1VC01 Owens Park, Fallowfield; Campus Redevelopment

Planning Amendments 18.03.19

Drawings & Issues Addressed

Pages 2-32
Elevations To Blocks 101-107 Showing Non-Material Amendments:

DRAWING TITLE: East and South Facing Elevations Building 101

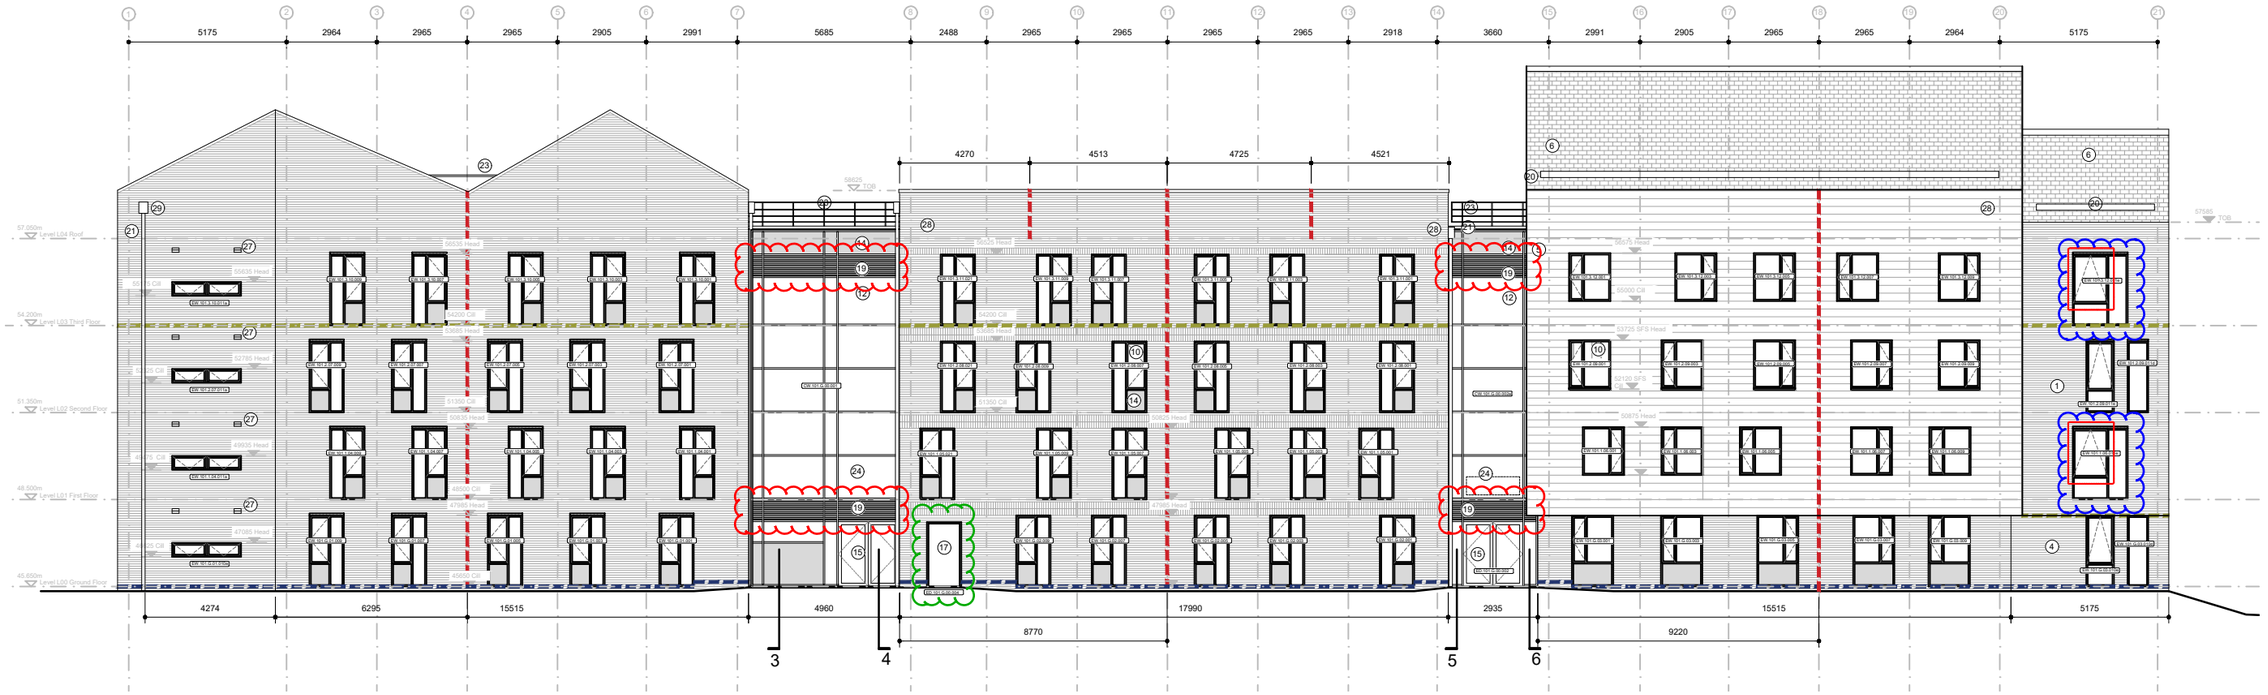
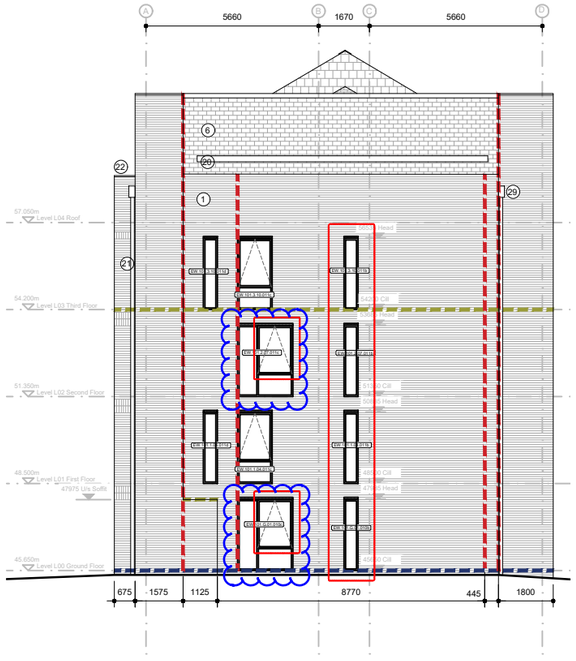
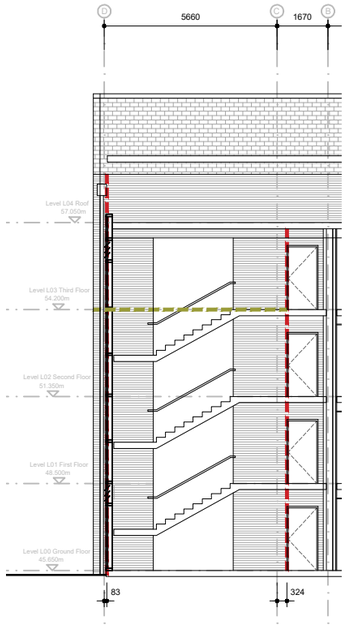
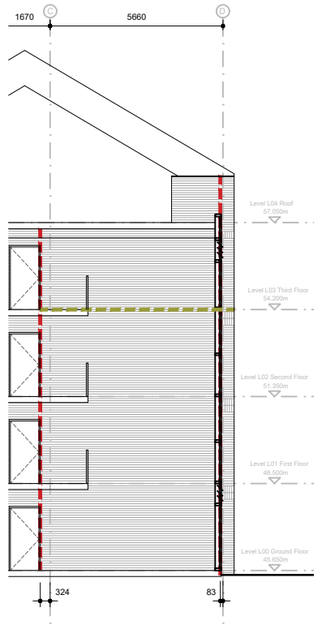
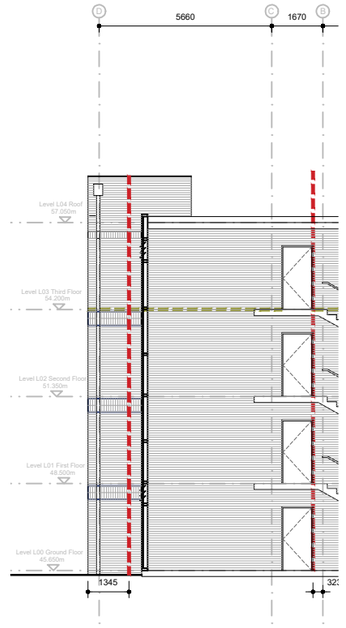
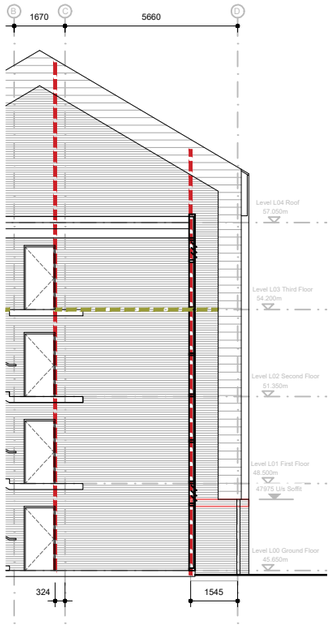
WINDOWS IN BLUE AMENDED TO BE TOP HUNG.

DOOR IN GREEN AMENDED TO BE SOLID METAL NOT LOUVRED.

GLASS LOUVRES AMENDED TO BE PPC METAL

DRAWING TITLE: West and North Facing Elevations Building 101

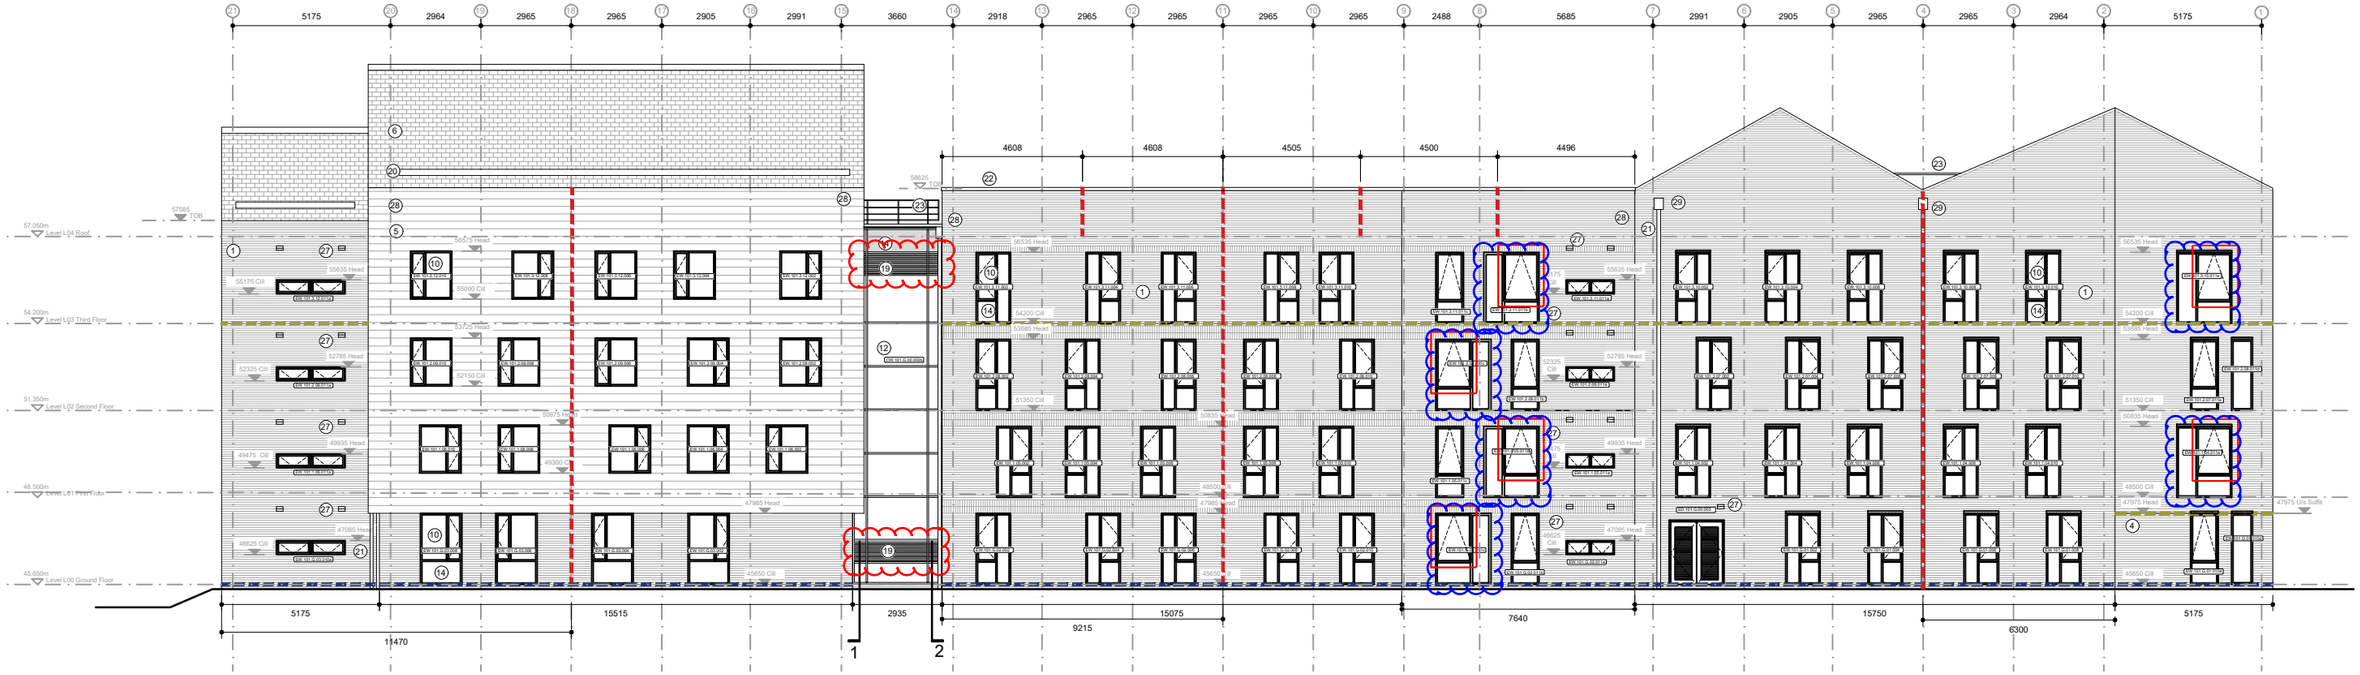
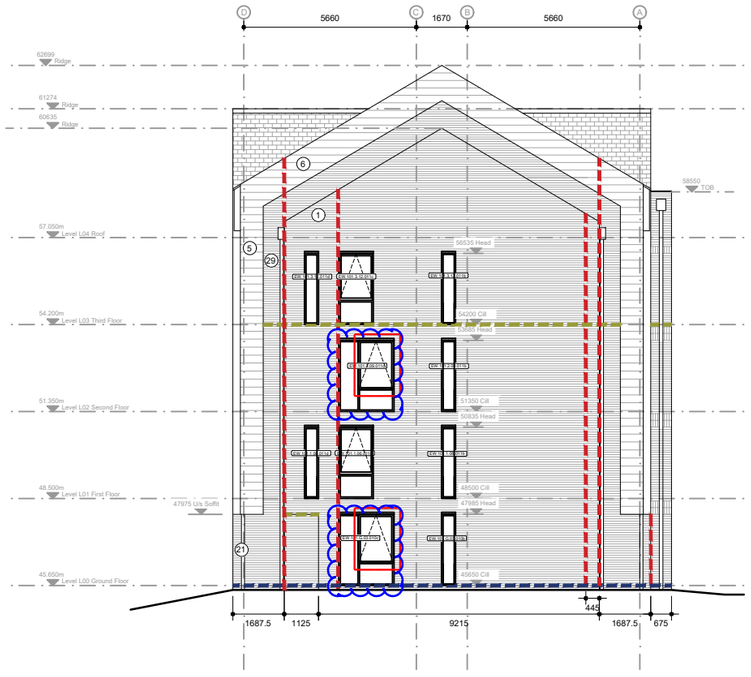
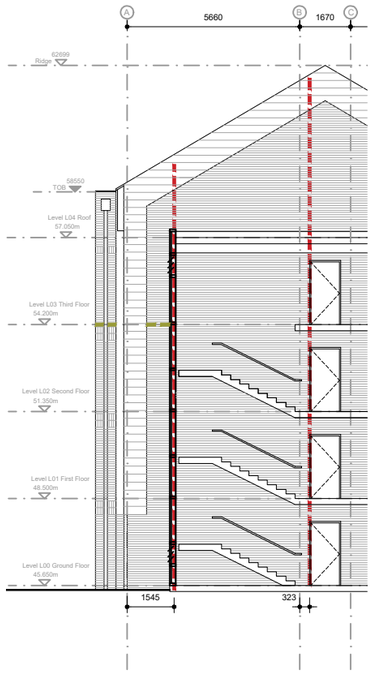
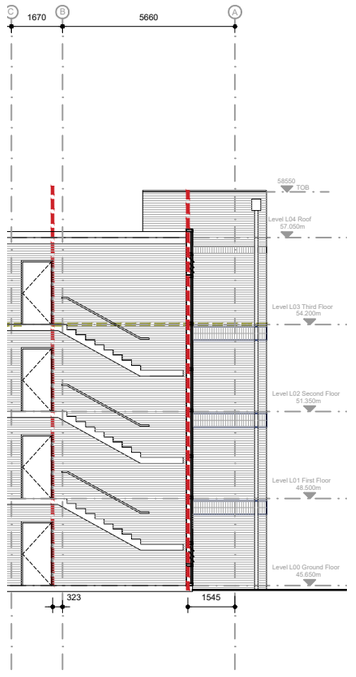
WINDOWS IN BLUE AMENDED TO BE TOP HUNG.

GLASS LOUVRES AMENDED TO BE PPC METAL

DRAWING TITLE
North and West Elevations - Building 103

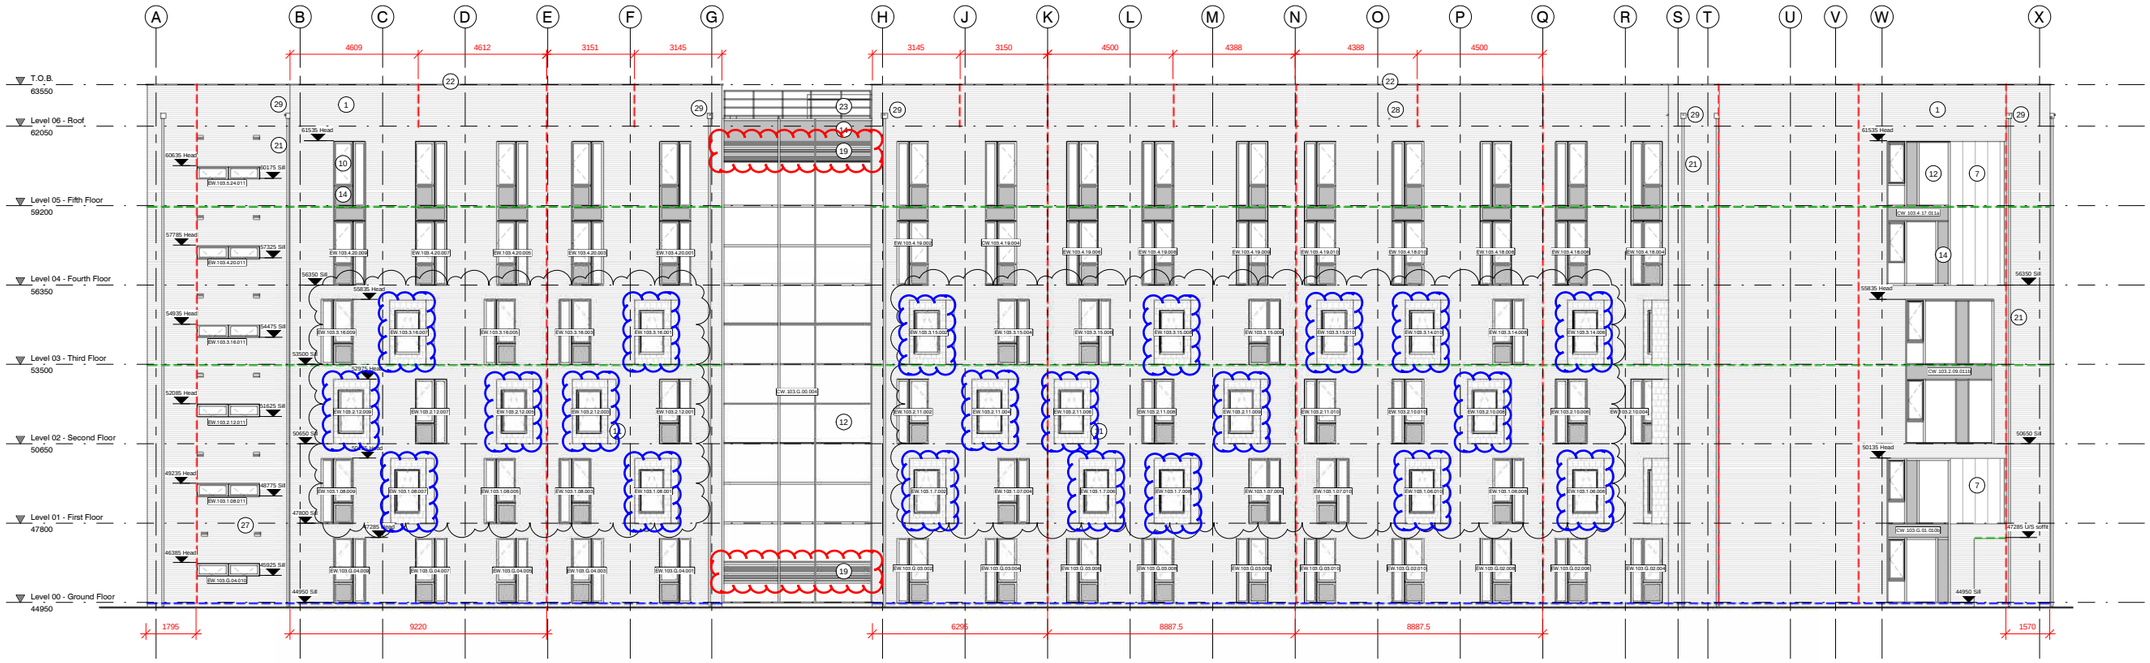
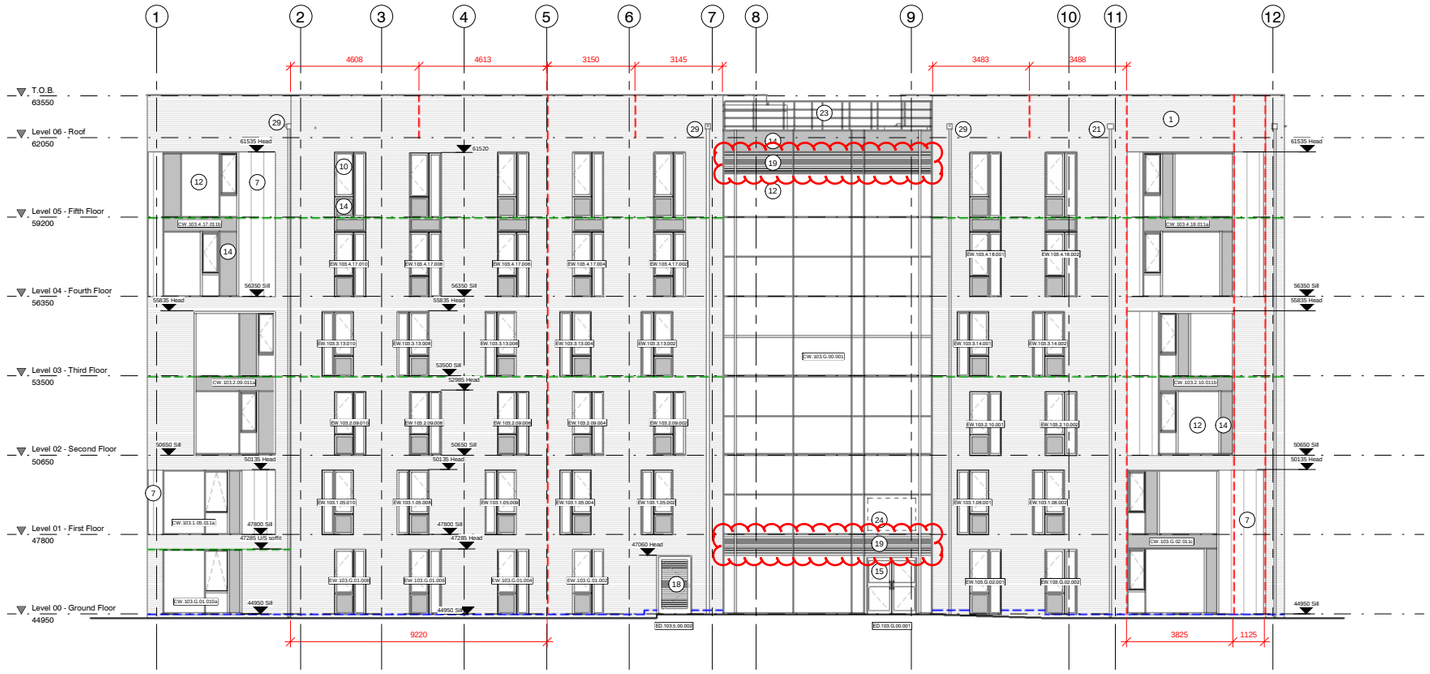
WINDOWS IN BLUE AMENDED TO BE TOP HUNG.

DRAWING TITLE
Internal Elevations - Building 104

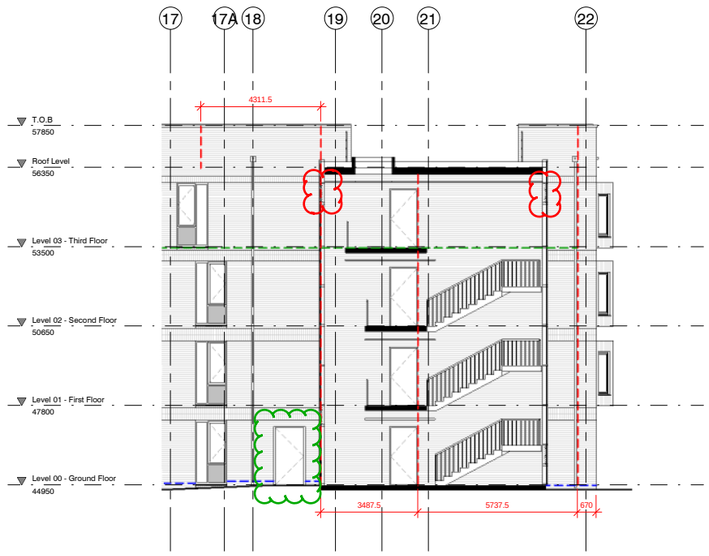
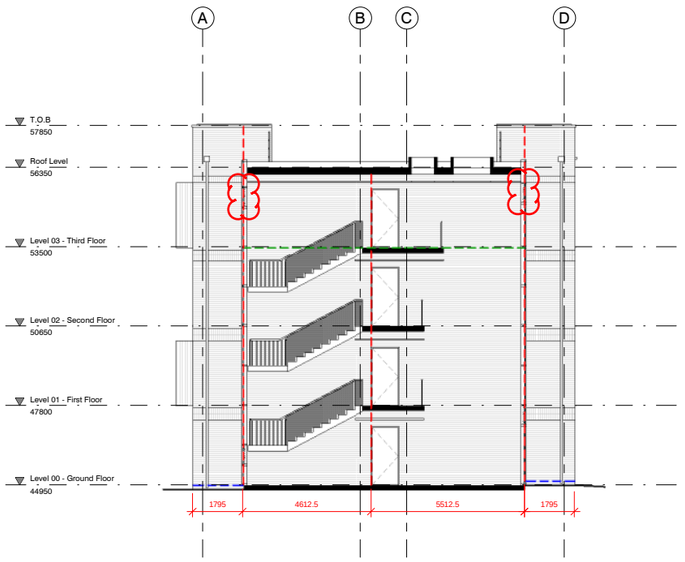
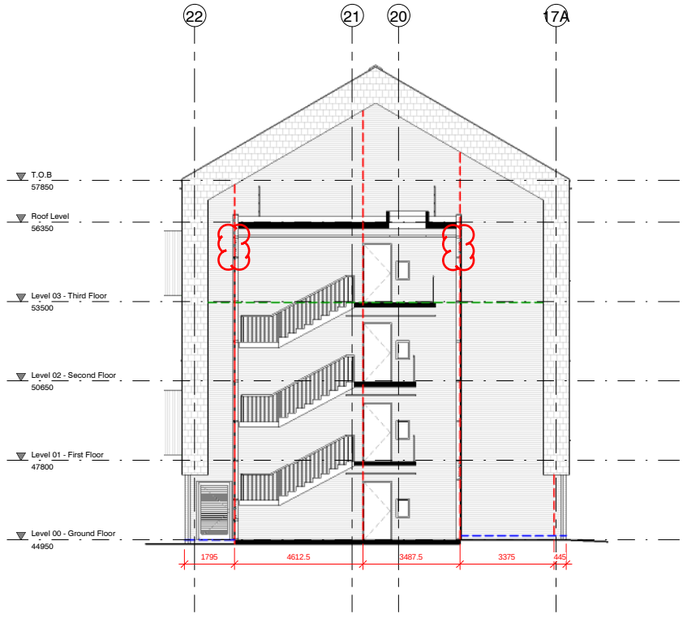
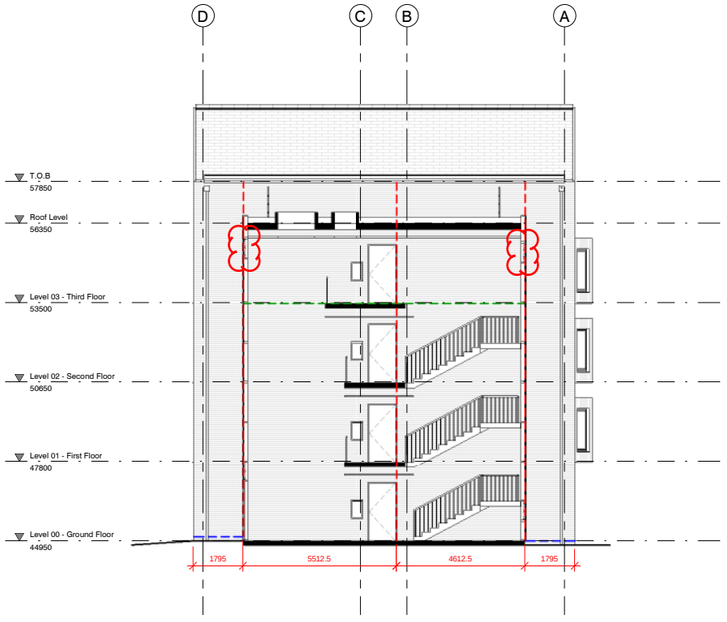
DOOR IN GREEN AMENDED TO BE SOLID METAL NOT LOUVRED

DRAWING TITLE
East and South Facing Elevations - Building 105

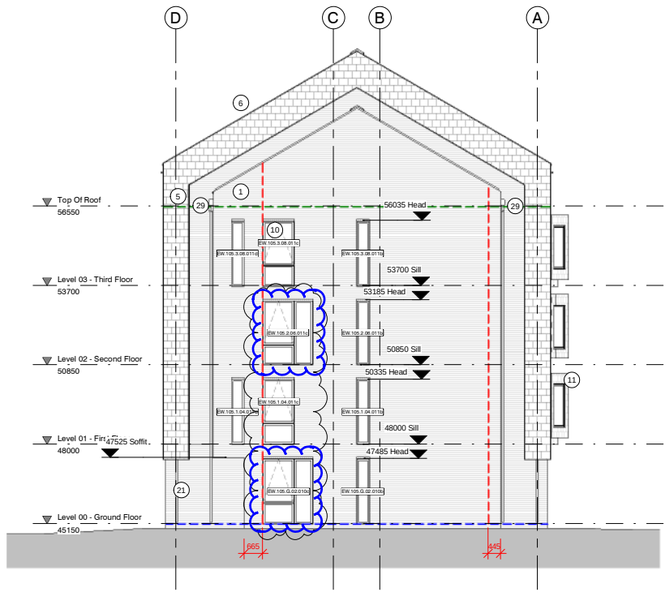
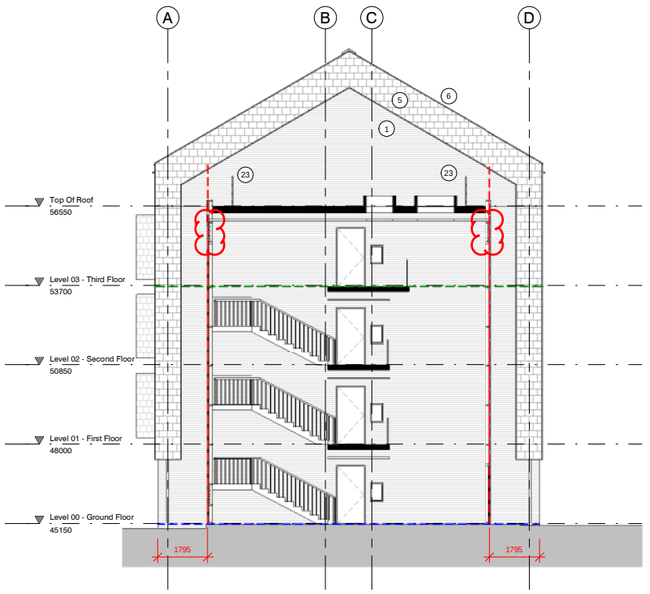
WINDOWS IN BLUE AMENDED TO BE TOP HUNG.

DRAWING TITLE
North and West Facing Elevations - Building 105

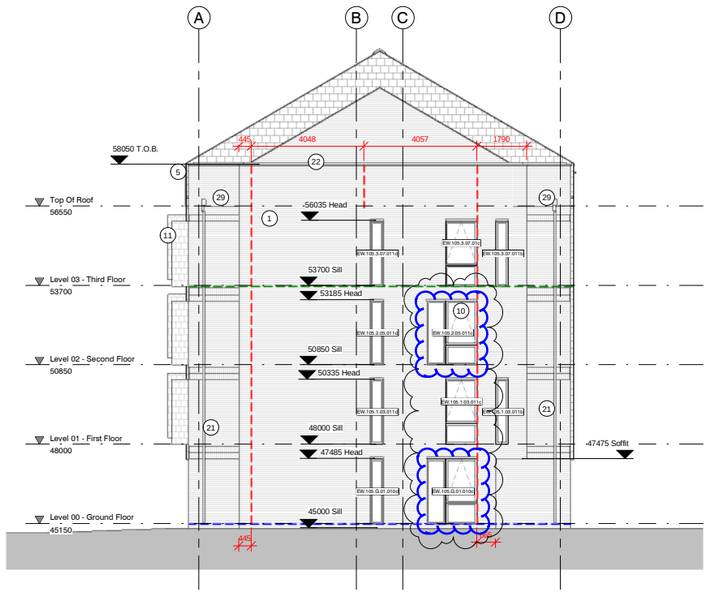
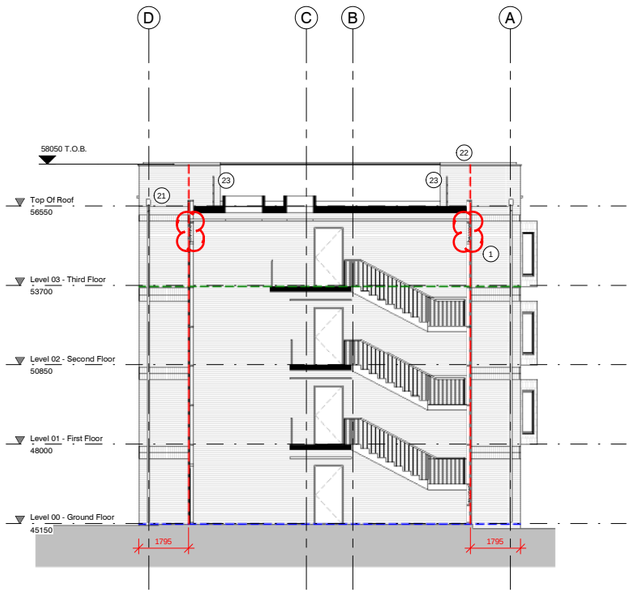
WINDOWS IN BLUE AMENDED TO BE TOP HUNG.
